From: Garrett, Christopher (SD)
Sent: Tuesday, March 24, 2009 4:13 PM
To: Catherine Hagan (George); Philip Wyels
Subject: FW: Poseidon project - Raimondi Initial Review
Attachments: Initial review of Impingement study and mitigation assessment.doc

Initial review of Impingement study and mitigation assessment – Carlsbad Seawater Desalinization Project

Pete Raimondi

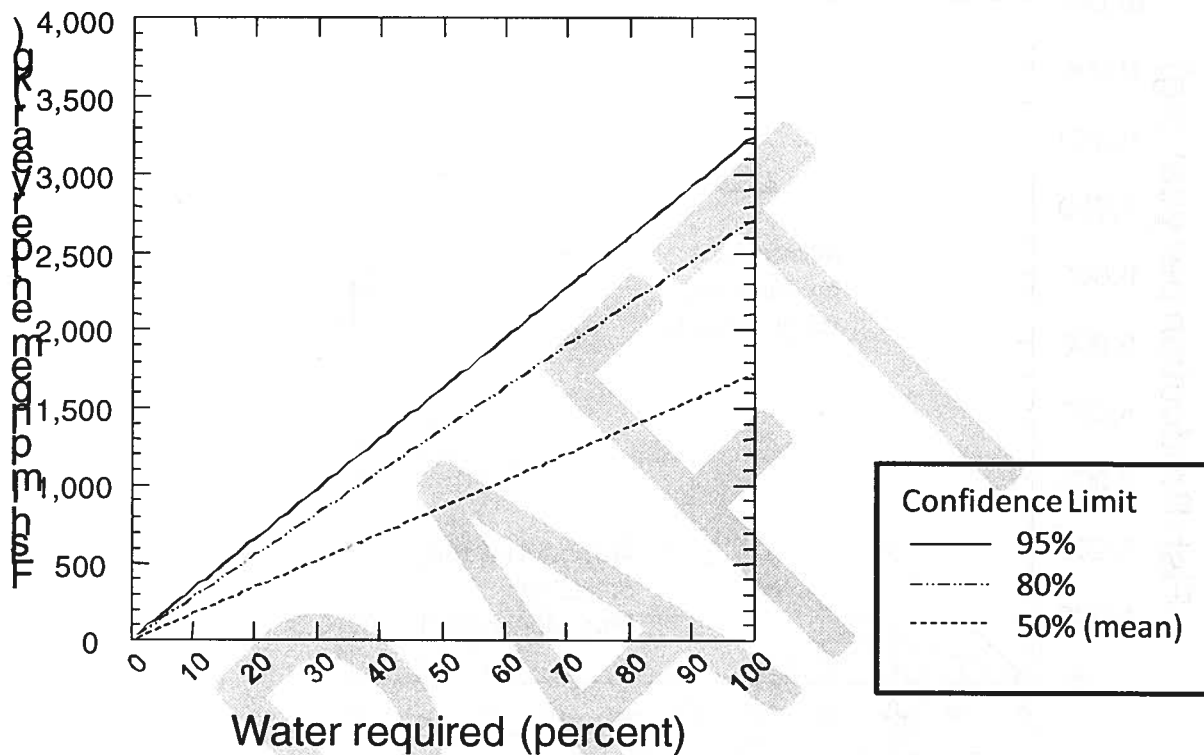
- 1) **This conclusion rests on the assumption of compensation.** Compensation is another name for density dependent mortality. As applied here it means that reduction in larval numbers due to entrainment has no effect on adult numbers. An example will be useful. Assume that a 100 acre wetland can naturally support 10000 kg of (non-larval) fish. Now assume that a powerplant is built and that the modeling of entrainments yields an estimate of the loss of 20% of the larval pool in the wetland. If fully compensatory mortality is assumed then there will be no change to the 10000 kg of non-larval fish. Now let's assume that no such compensation occurs (note that the use of compensatory mortality has not been allowed in any recent entrainment assessments (316B or equivalent)) - here the 10000 kg will decrease to 8000kg (assuming only a change in numbers of fish and no change in size structure). If there is impingement of say 1000 kg of fish per year, the overall biomass will decrease to 7000 kg. Okay an assessment is made of entrainment and mitigation is required that will produce the same number of larvae as that lost to entrainment. Assume this is in the form of ~20 new wetland acres. Again we make the mandated assumption of no compensatory mortality and we conclude that the non-larval biomass for the wetland will go up 2000kg yielding 9000kg (7000+2000). What about the missing 1000kg? That amount is still missing due to impingement. Based on the logic and math above another 10 acres of new wetland would be needed to produce the biomass lost to impingement.

The bottom line is that wetland acreage created or restored based on entrainment impacts cannot be also used to mitigate for impingement impacts unless one invokes compensatory mortality, which is specifically not done in I&E determinations.

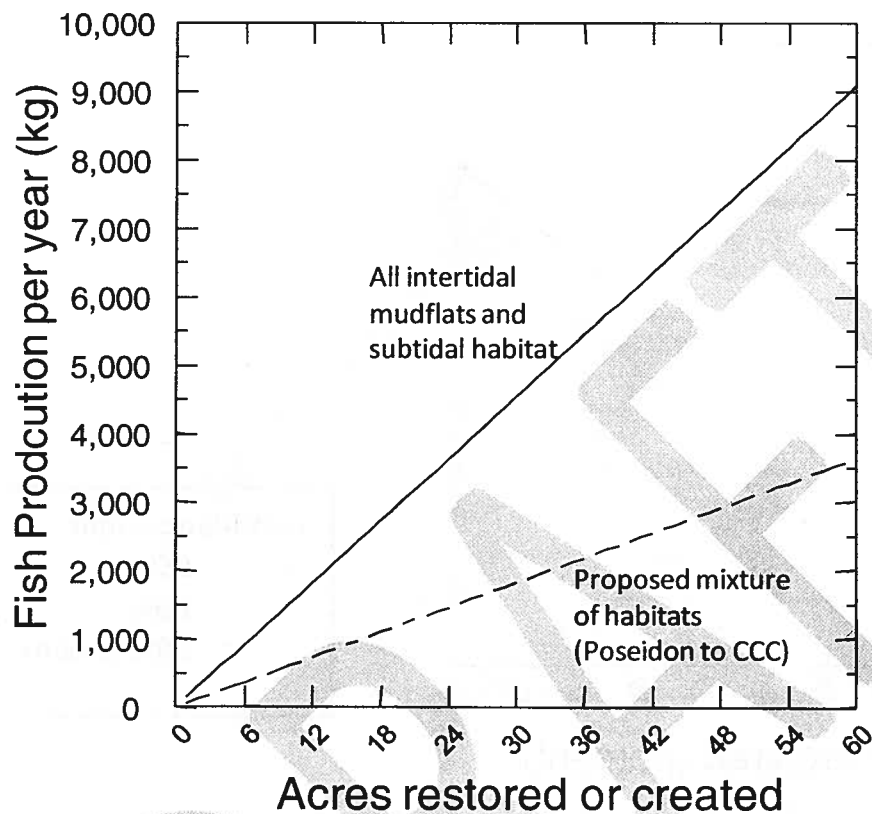
First, impingement losses are shown as a function of the percent of water required (not supplied by the power plant operations).

Like the estimate produced by Poseidon and used by Nordby, if CDP requires 100% new water the estimate of impingement based on the arithmetic mean is ~1715 kg. Note though that if the 80 or 95% confidence limit is used the value increases to 2700 kg (80% CL) or 3250 kg (95% CL).

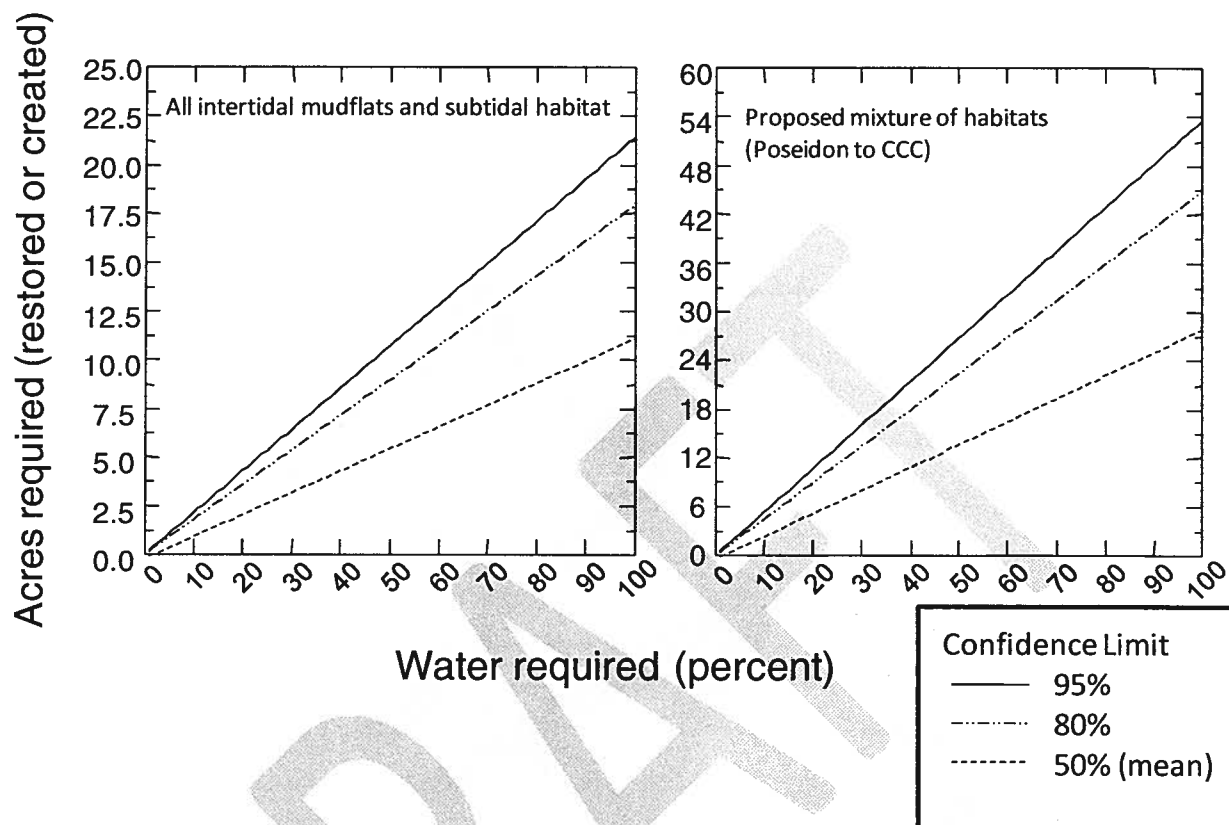
Next I estimated the production of fish as a result of the restoration or creation of new wetland habitat (***not the acreage to be restored or created as a result of entrainment mitigation***), under two scenarios. First, assuming the new wetland would be all intertidal mudflat or subtidal habitats. Second using a mixture of habitats of which 40% is intertidal mudflats or subtidal.
